Roosevelt Lofts – Historic Rehabilitation & New Apartments – 22-3281

ADDENDUM NO. 1

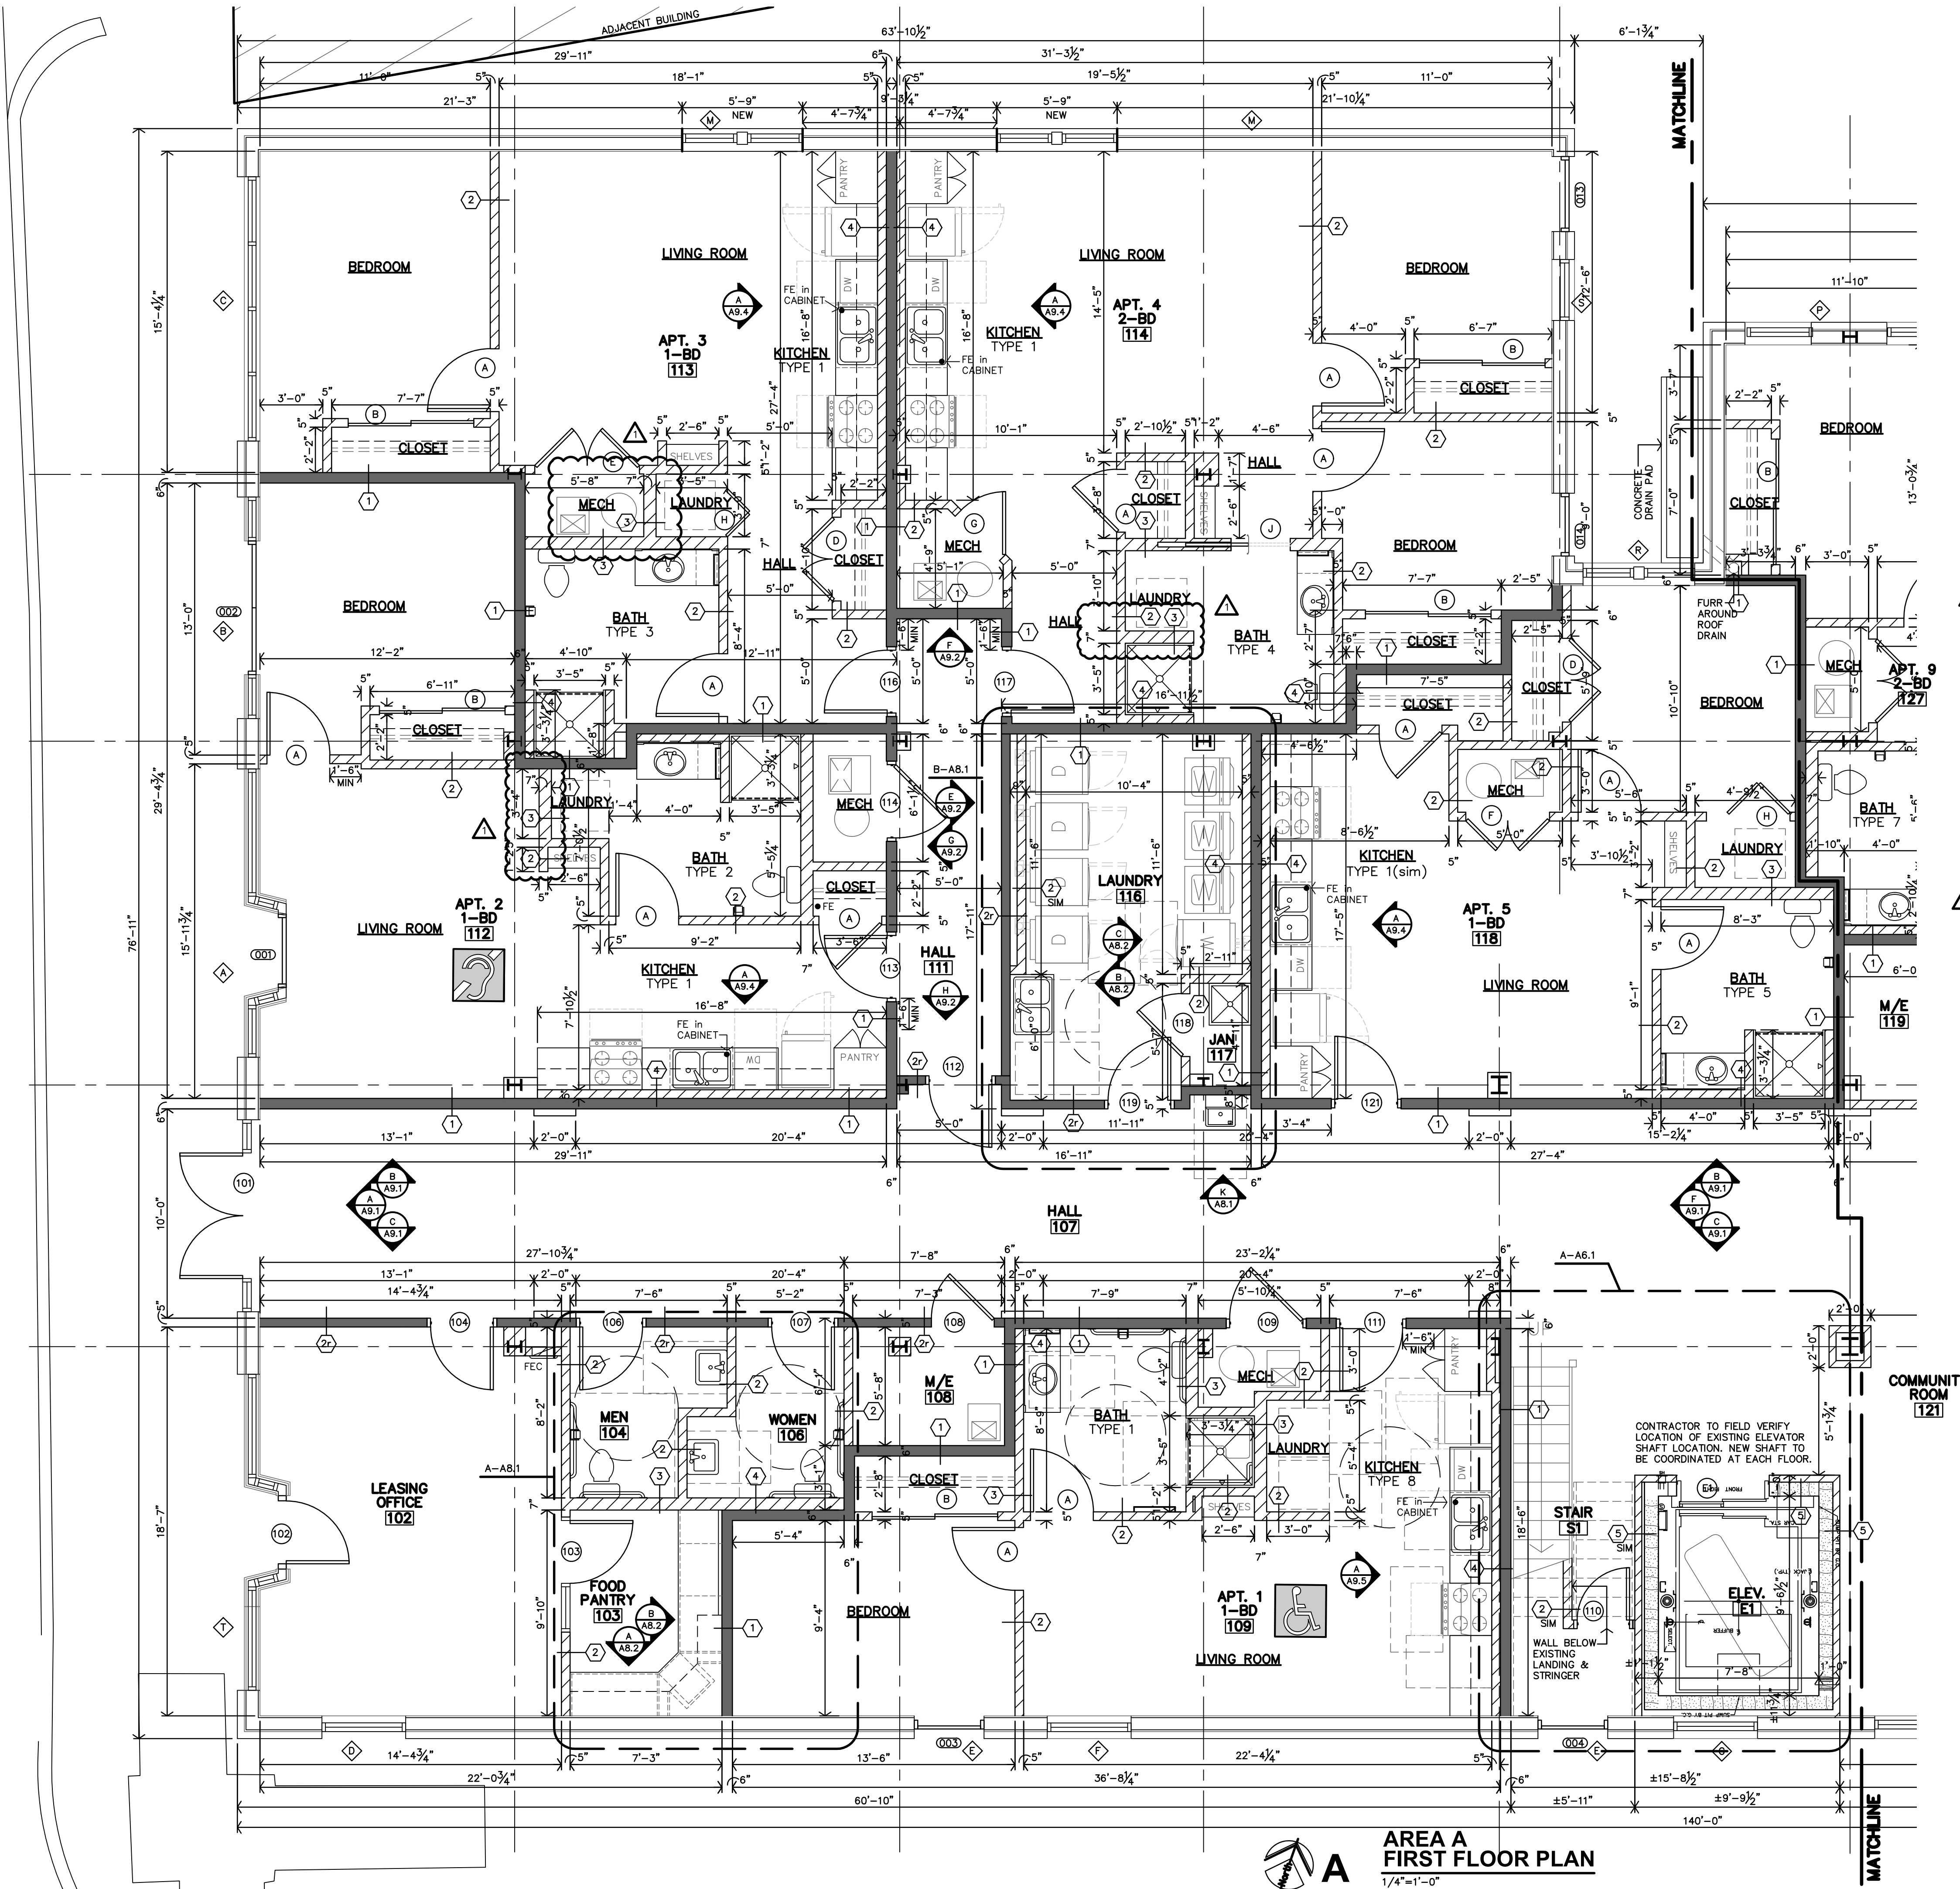
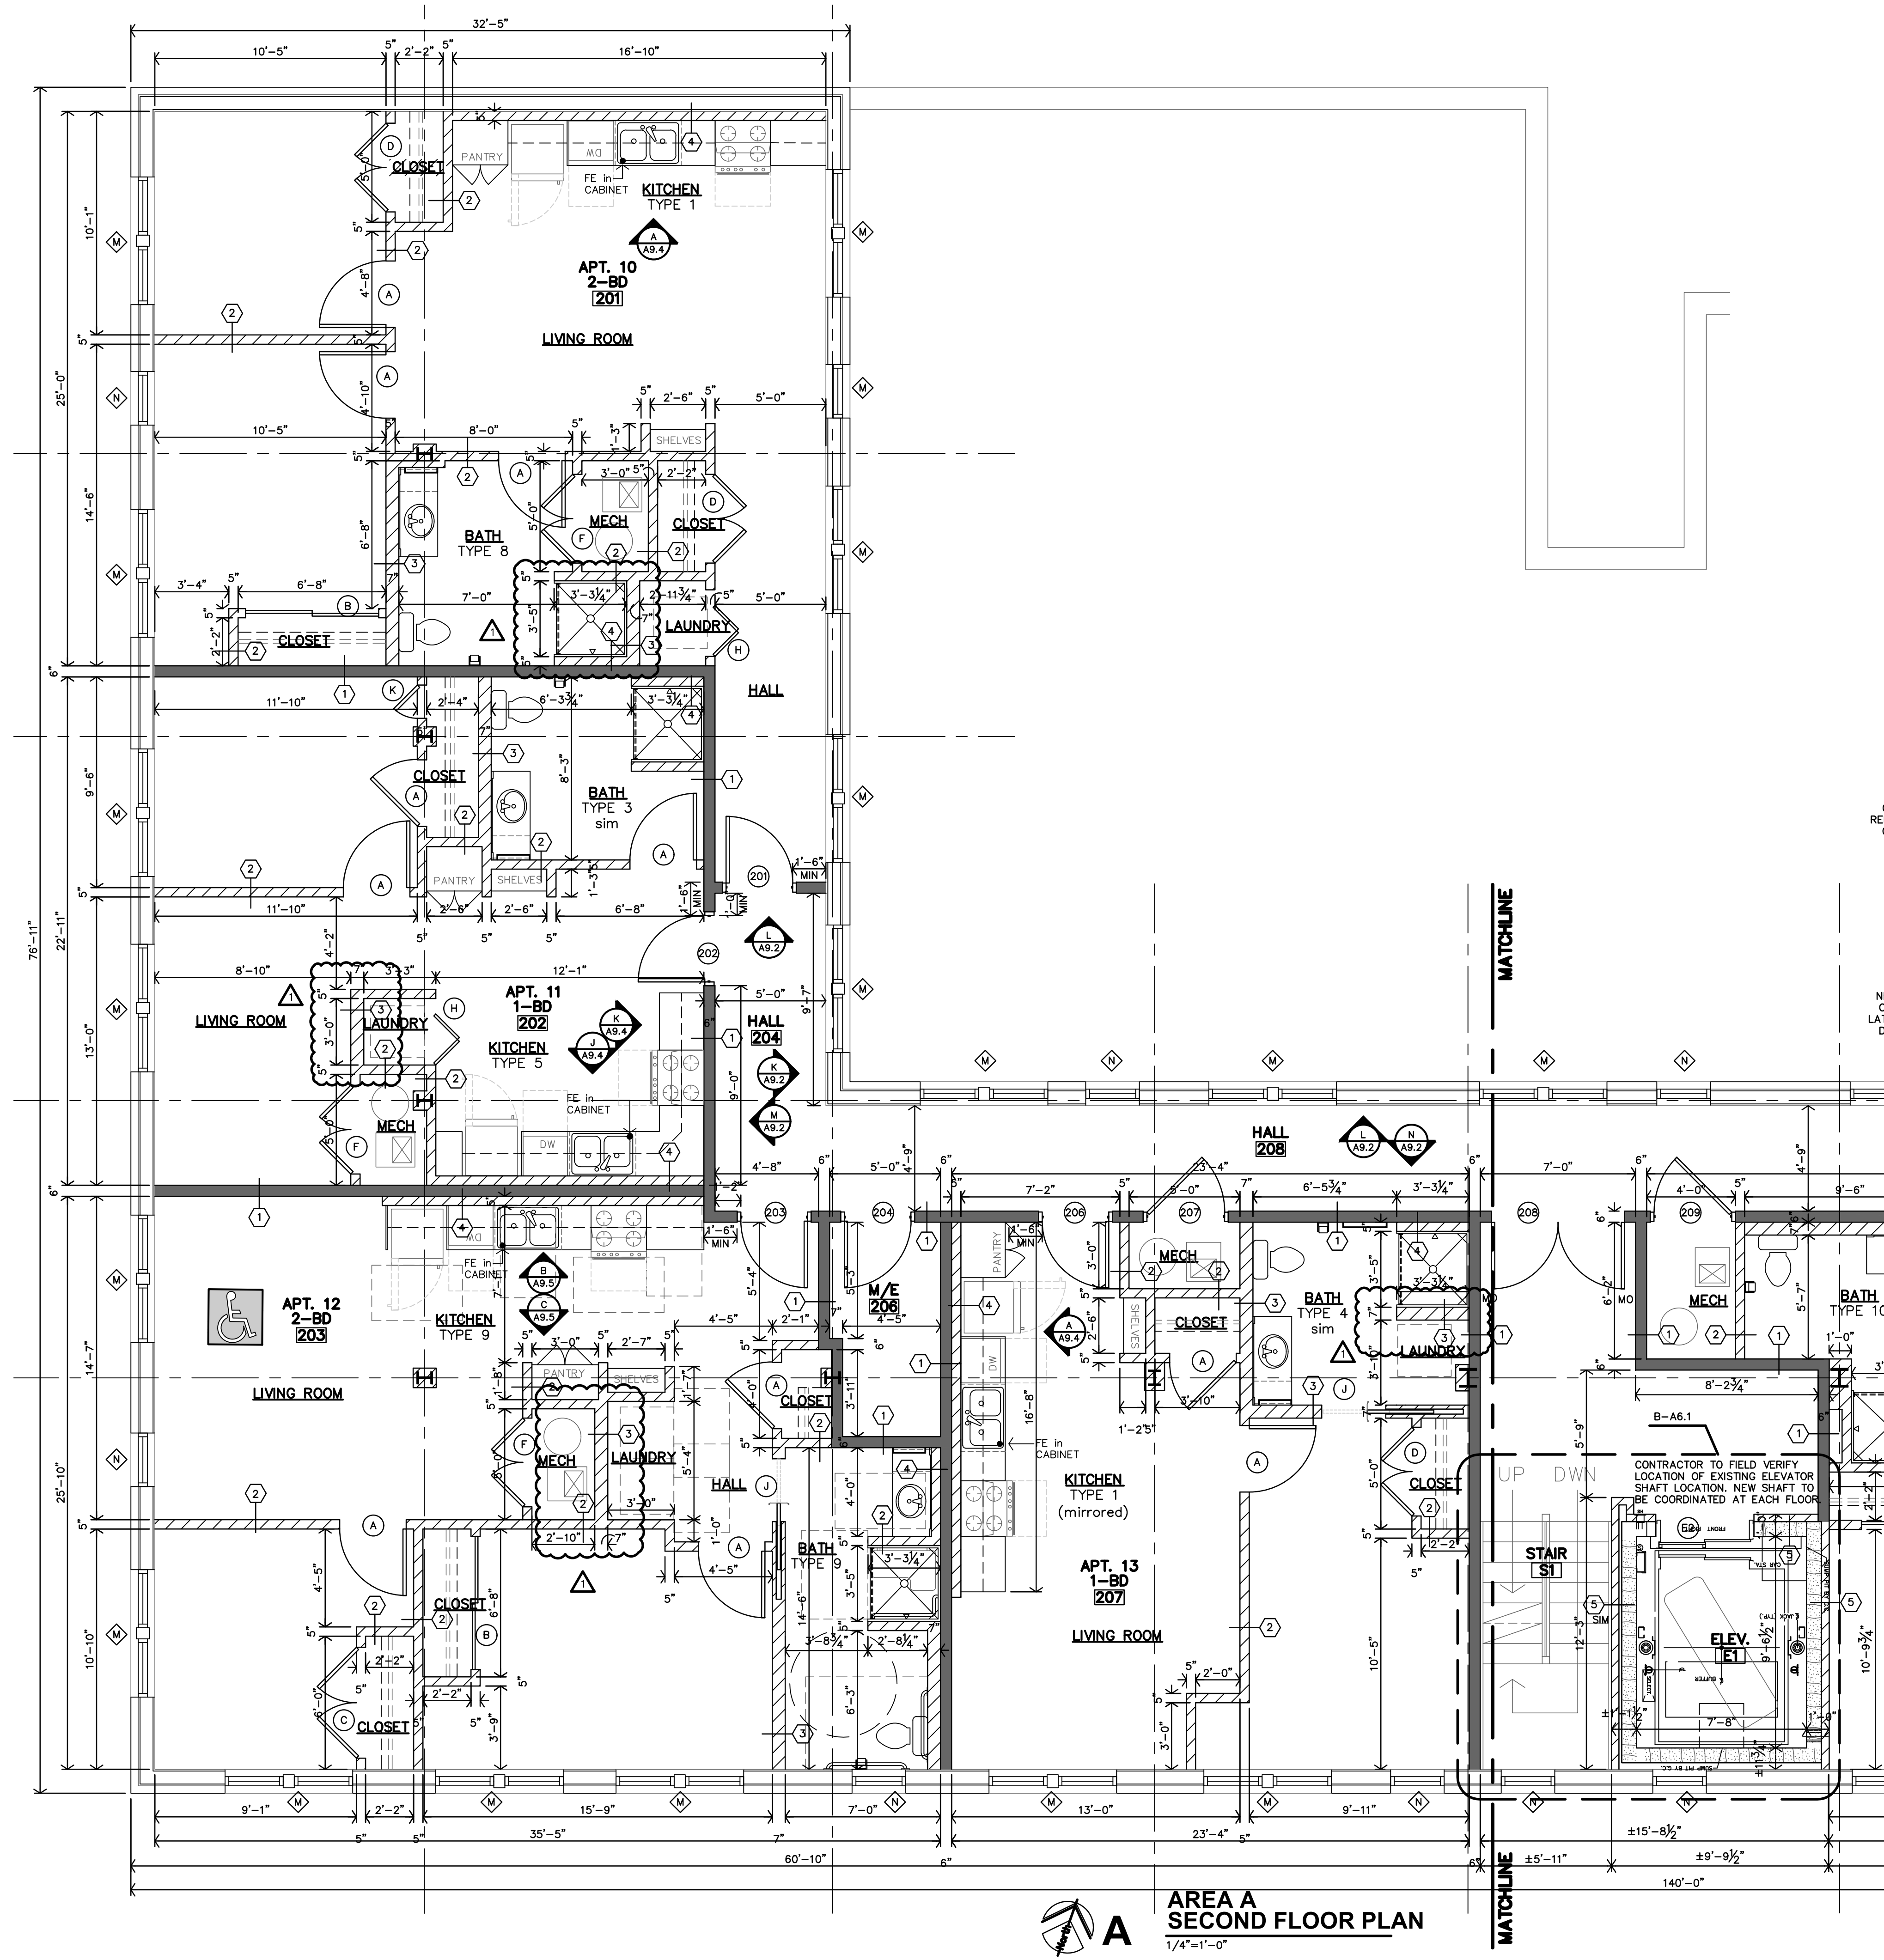
- b. Add wall Type 1B
5. Sheets A2.3 – A2.8 – Several places where walls have been thickened to a 2x6 stud vs. a 2x4 to allow for plumbing and vent ducts to route up through them.

- a. Unit 112 – wall behind Laundry has been changed to a Type 3
 - b. Unit 113 – wall in-between Laundry and Mech has been changed to a Type 3
 - c. Unit 114 – wall in-between Laundry and shower has been changed to a Type 3

- d. Unit 122 – wall behind Laundry has been changed to be 7" thick vs. 5" thick.
 - e. Unit 123 – wall behind Laundry has been changed to be 7" thick vs. 5" thick

- f. Unit 127 – wall behind Laundry has been changed to be 7" thick vs. 5" thick
 - g. Unit 201 – wall in-between Laundry and Shower has been changed to a Type 3

- h. Unit 202 – wall behind Laundry has been changed to a Type 3
 - i. Unit 203 – wall in-between Laundry and Mech has been changed to a Type 3
 - j. Unit 207 – wall in-between Laundry and Shower has been changed to a Type 3

- k. Unit 212 – portion of wall in-between Units 212 & 213 has been changed to a Type 1B

- l. Unit 213 – wall in-between closet and refrigerator has been changed to a Type 3
 - m. Unit 301 – wall in-between shower and laundry has been changed to a Type 3

- s. Unit 313 – wall in-between closet and refrigerator has been changed to a Type 3. Wall in-between shower and vanity has been changed to a Type 3.
6. Sheet A3.1
